Addendum, Change Order, Drawing, Deferred Approval Worksheet and Transmittal Memo

**EVALUATION AND DESIGN CRITERIA REPORT
REVISION 3
DSA BACKCHECK**

BERKELEY CITY COLLEGE

KPW Project No 16C129
DSA APPLICATION #01REH-10075

REH REPORT
REVISION 3
MATERIAL
TESTING AND
REPAIR

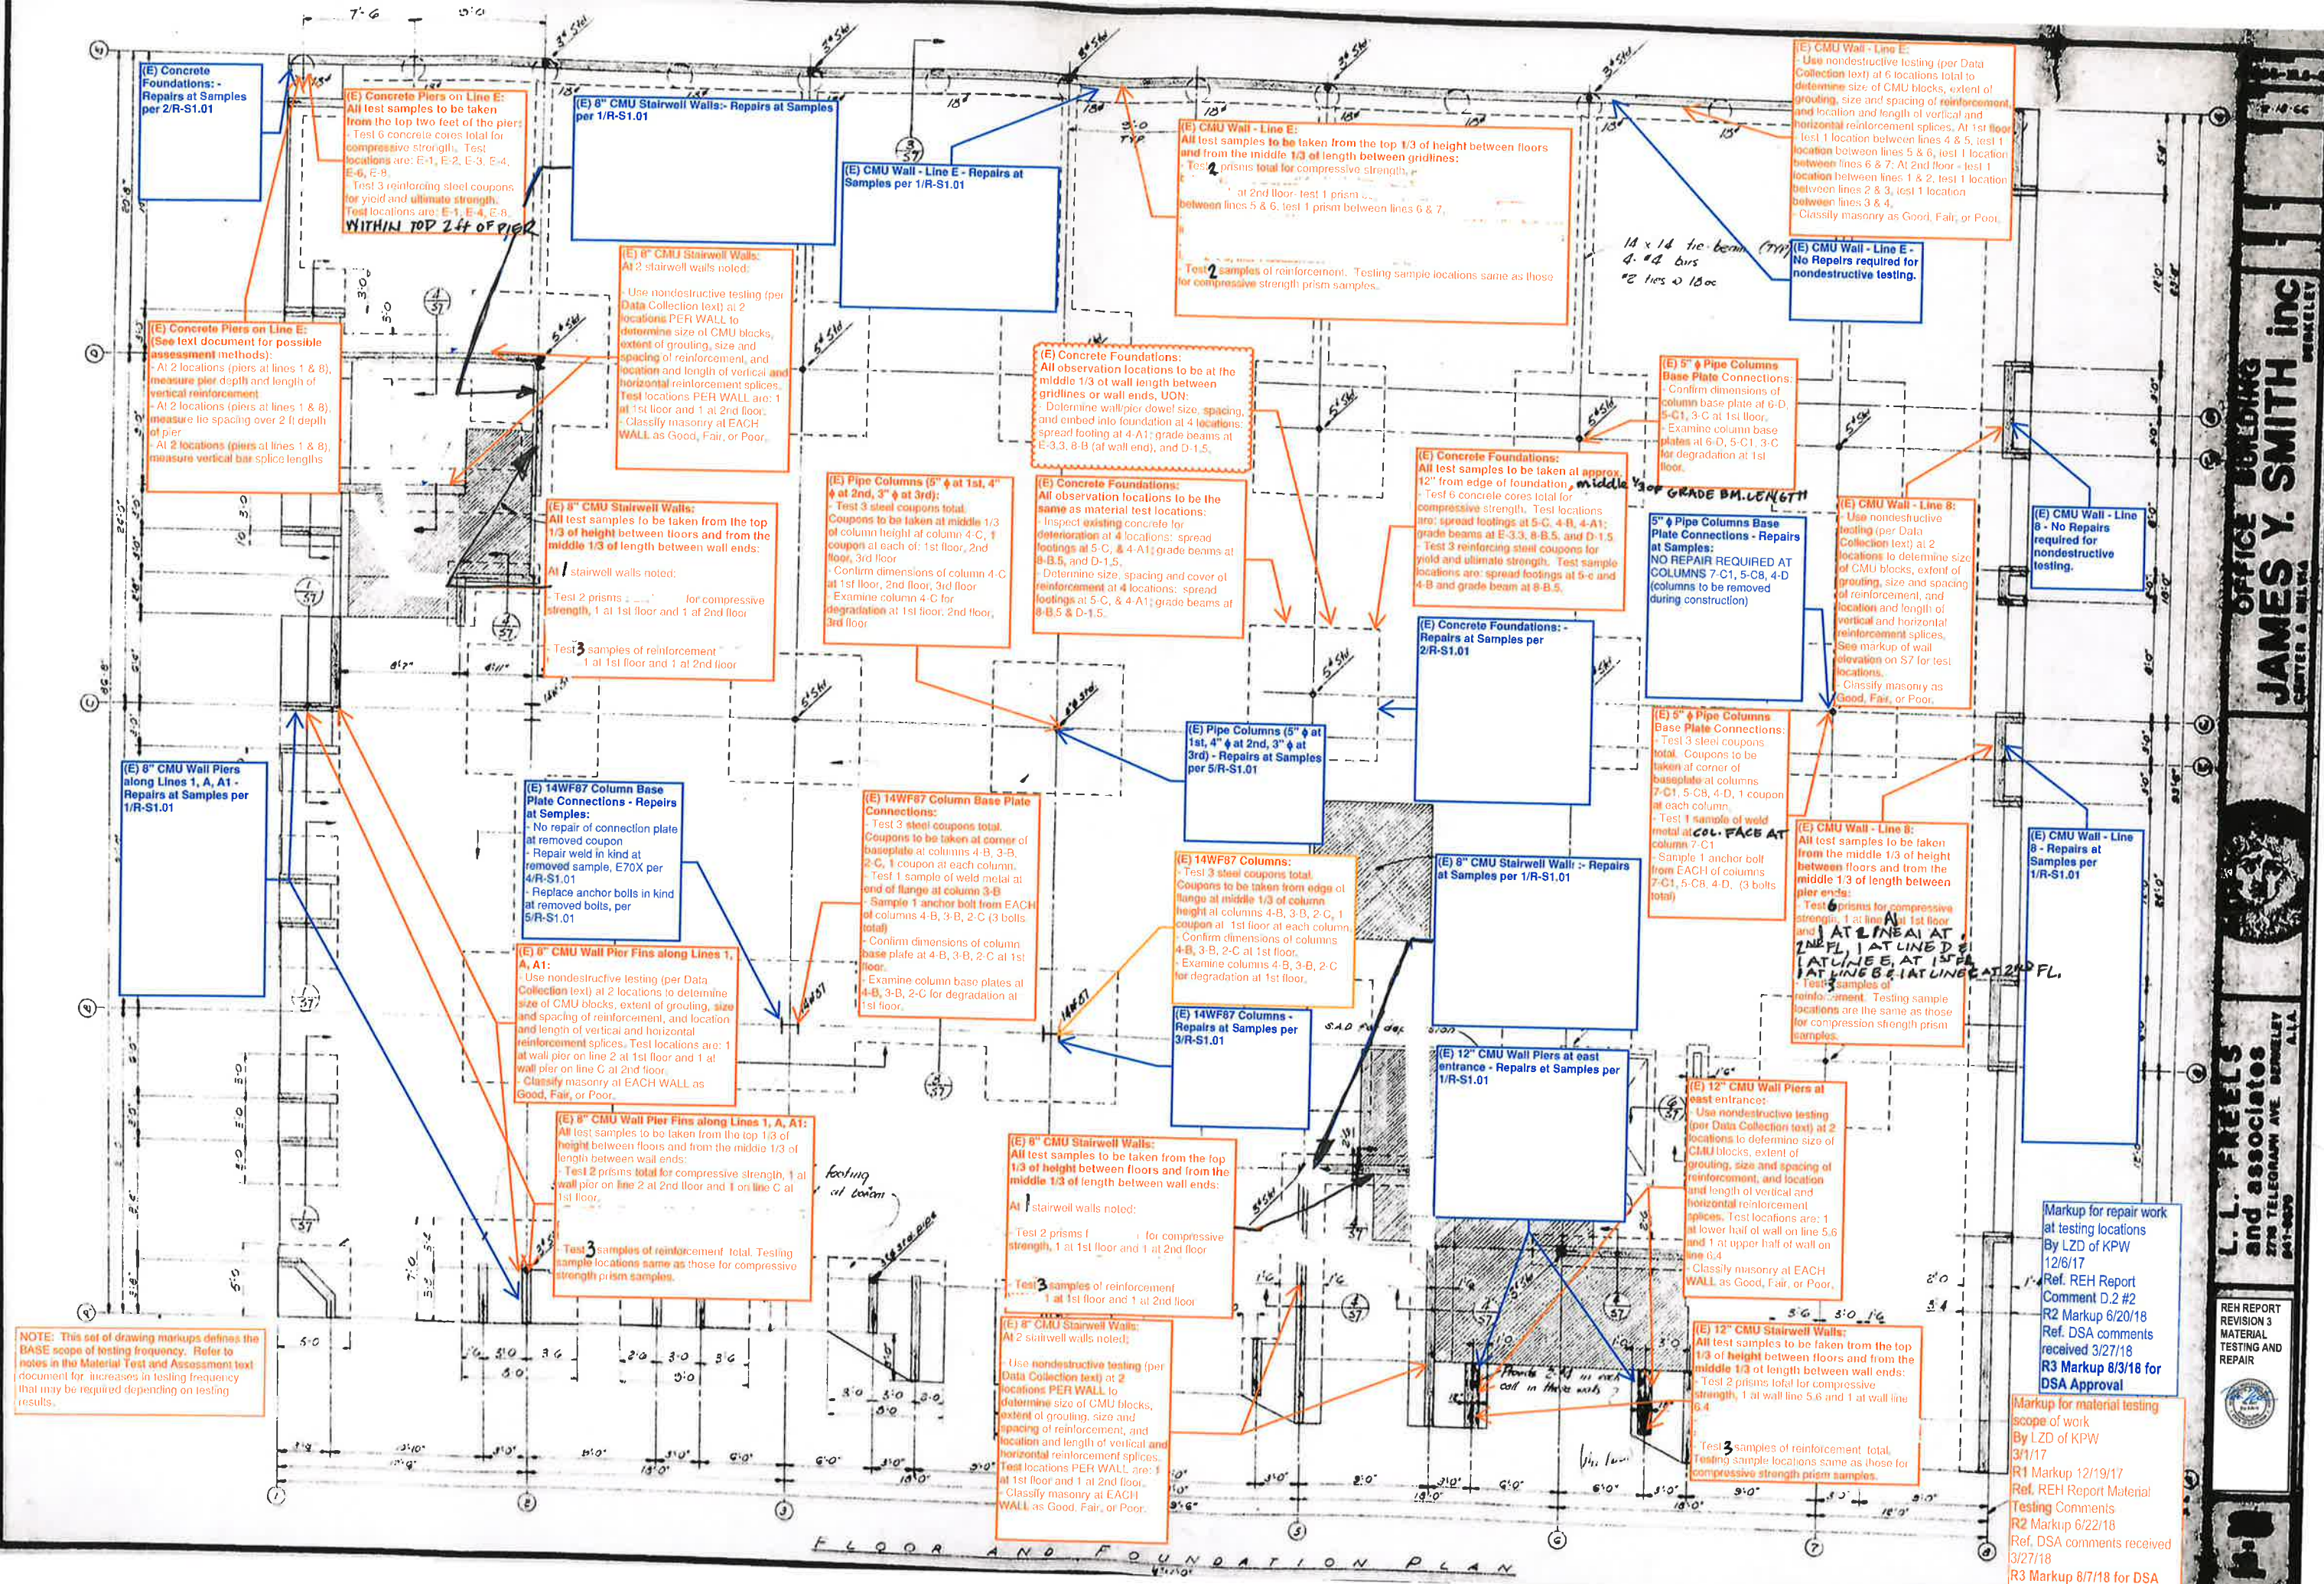
Markup for repair work
at testing locations
By LZD of KPW
12/6/17
Ref. REH Report
Comment D.2 #2
R2 Markup 6/20/18
Ref. DSA comments
received 3/27/18
R3 Markup 8/3/18 for
DSA Approval

(E) 4" Pipe Columns Base Plate Connections at 2nd Floor - Repairs at Samples:
- No repair of connection plate at removed coupon.
- Repair weld in kind at removed sample, E70X per 4/R-S1.01.
- Replace bolts in kind at removed bolts, match diameter, A307 bolts per 7/R-S1.01.

(E) 14WF Girder Splice Connections - Repairs at Samples:
- No repair of connection plate at removed coupon.
- Repair weld in kind at removed sample, E70X per 4/R-S1.01.
- Replace bolts in kind at removed bolts, match diameter, A307 bolts per 7/R-S1.01.

(E) 10WF21 to (E) 14WF30 Connections - Repairs at Samples:
- No repair of connection plate at removed coupon.
- Repair weld in kind at removed sample, E70X per 4/R-S1.01.
- Replace bolts in kind at removed bolts, match diameter, A307 bolts per 7/R-S1.01.

(E) 14WF Girder and 10WF Beam to 14WF Column Connections - Repairs at Samples:
REPAIR PLATE PER 3/R-S1.01 SIM.
- Repair weld in kind at removed sample, E70X per 4/R-S1.01.
- Replace bolts in kind at removed bolts, match diameter, A307 bolts per 7/R-S1.01.

Markup for material testing
scope of work
By LZD of KPW
3/1/17
R1 Markup 12/19/17
Ref. REH Report Material
Testing Comments
R2 Markup 6/22/18
Ref. DSA comments received
3/27/18
R3 Markup 8/7/18 for DSA
approval

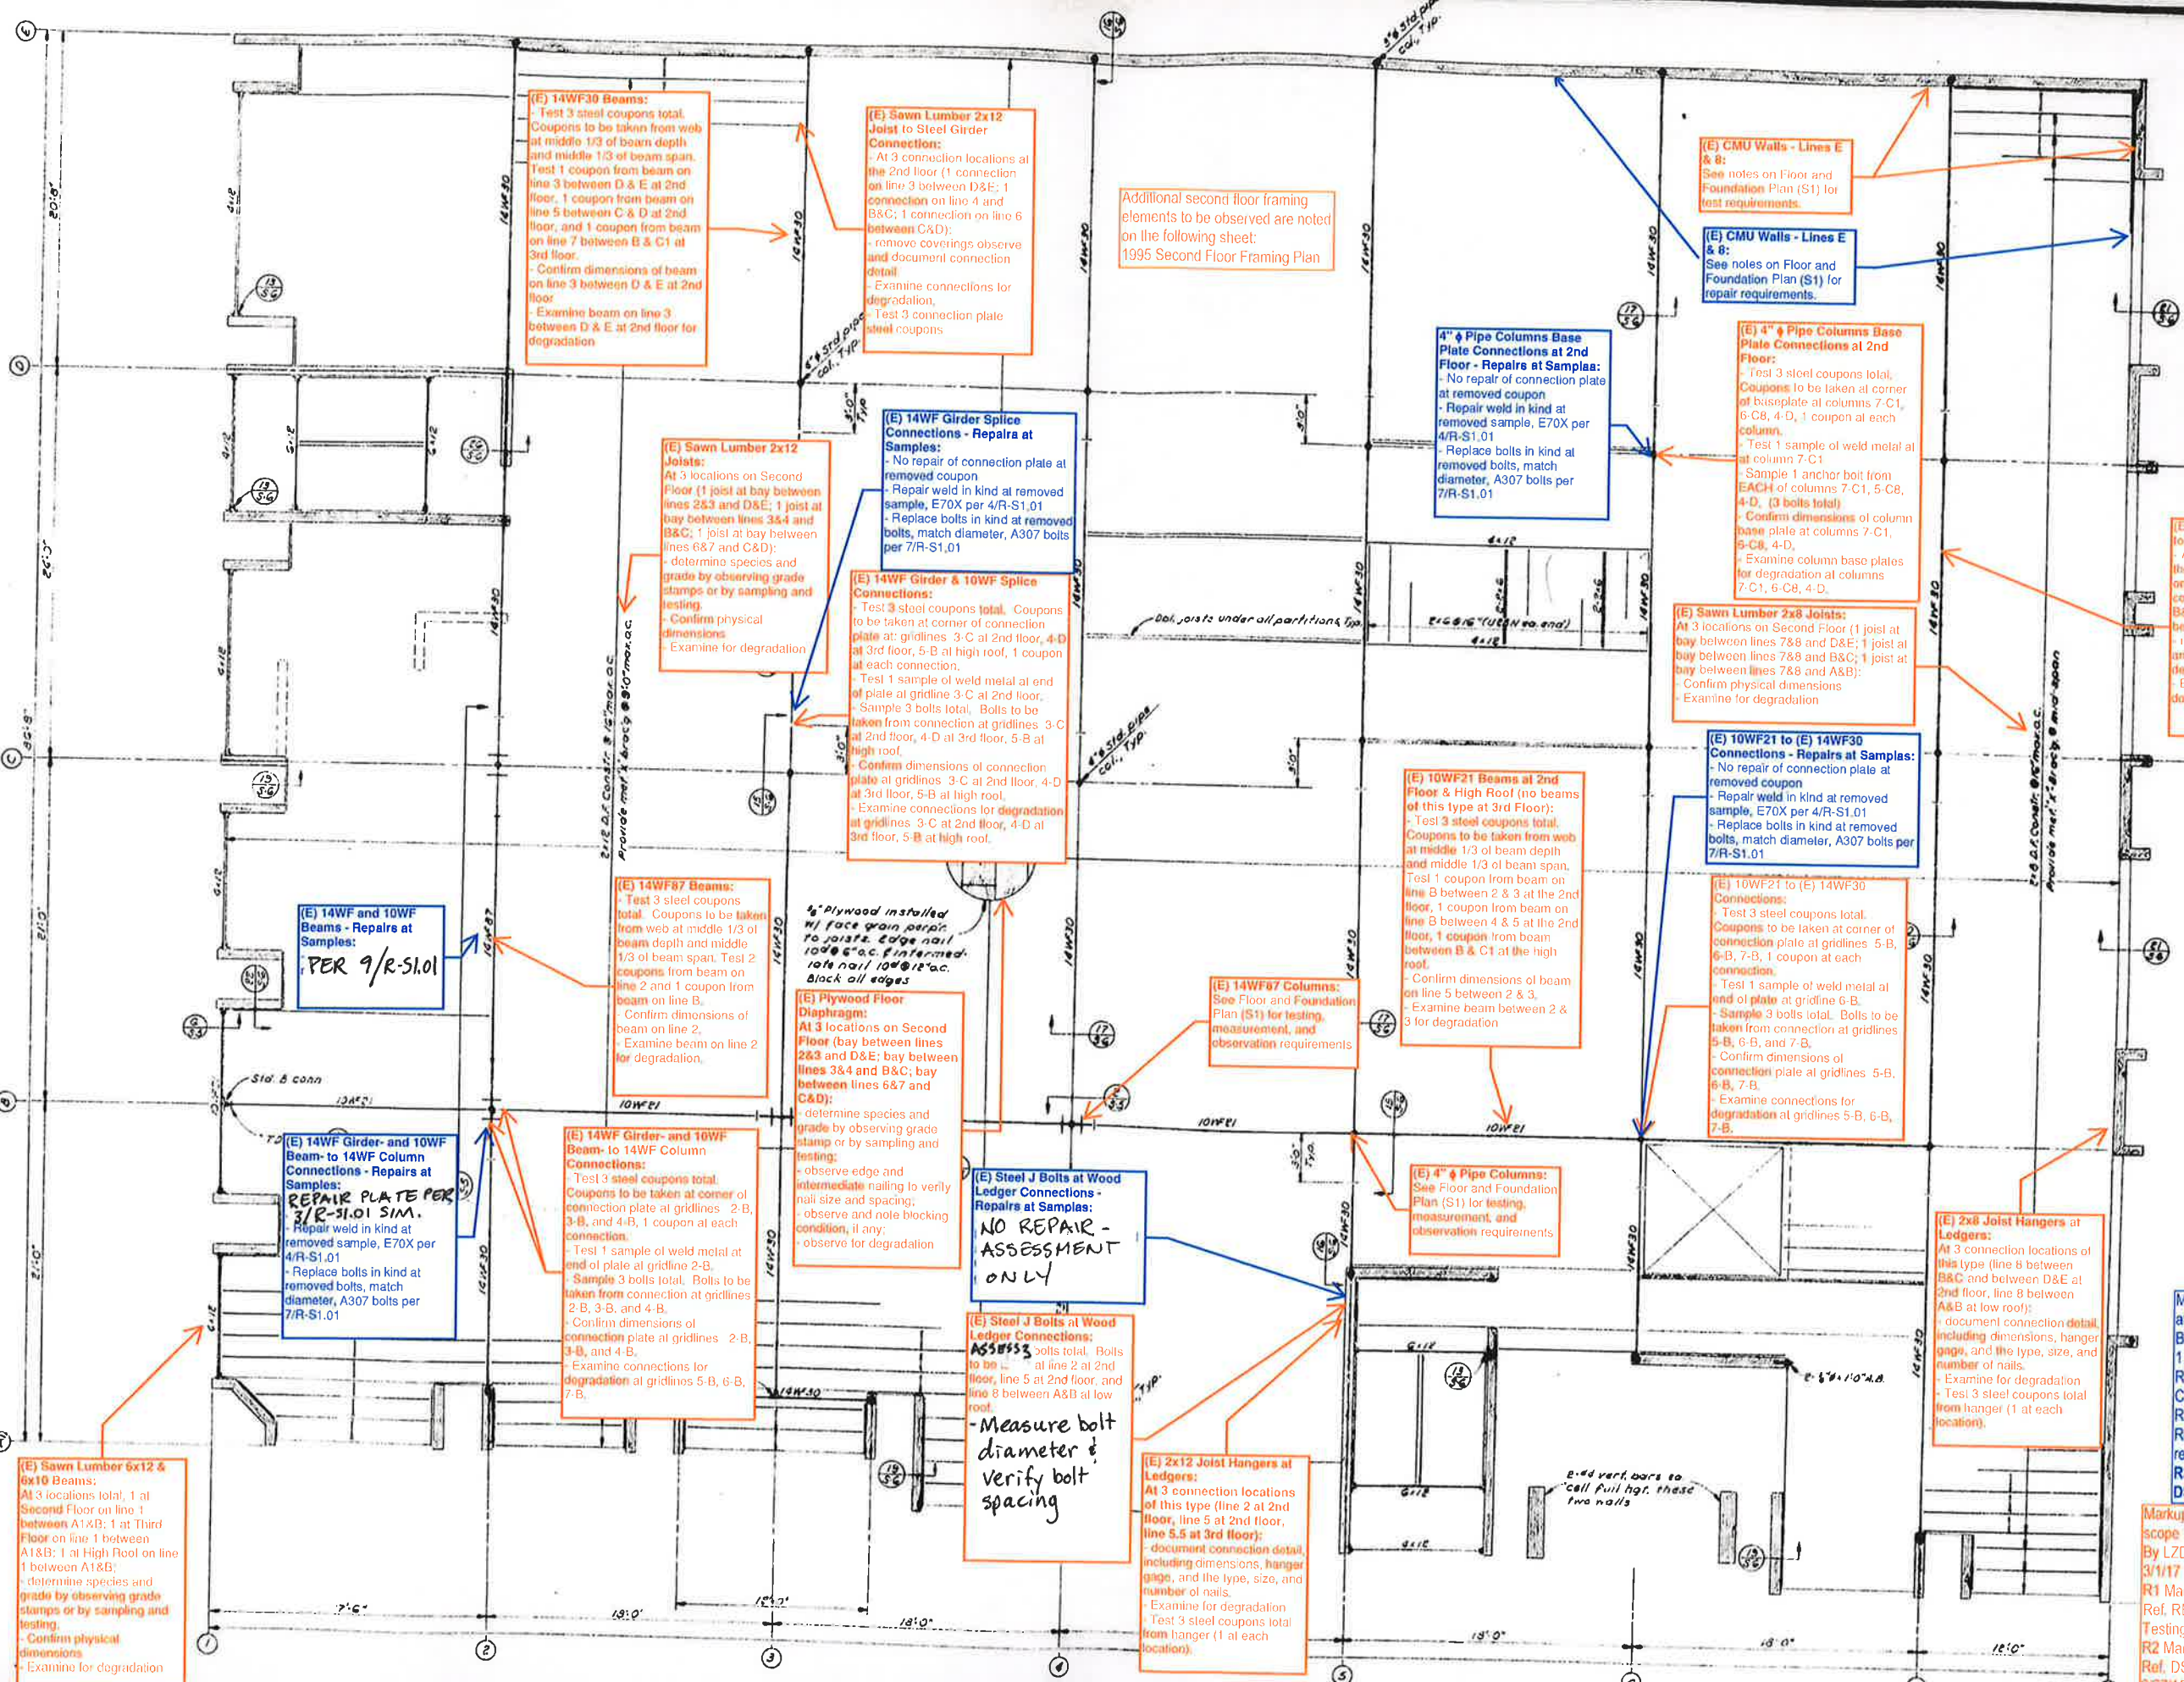
Additional second floor framing elements to be observed are noted on the following sheet:
1995 Second Floor Framing Plan

(E) 2x12 Joist Hangers at Ledgers:
At 3 connection locations of this type (line 2 at 2nd floor, line 5 at 2nd floor, line 5.5 at 3rd floor).
- document connection detail, including dimensions, hanger gage, and the type, size, and number of nails.
- Examine for degradation.
- Test 3 steel coupons total from hanger (1 at each location).

(E) Sawn Lumber 6x12 & 6x10 Beams:
At 3 locations total, 1 at Second Floor on line 1 between A1&B; 1 at Third Floor on line 1 between A1&B; 1 at High Roof on line 1 between A1&B.
- determine species and grade by observing grade stamps or by sampling and testing.
- Confirm physical dimensions.
- Examine for degradation.
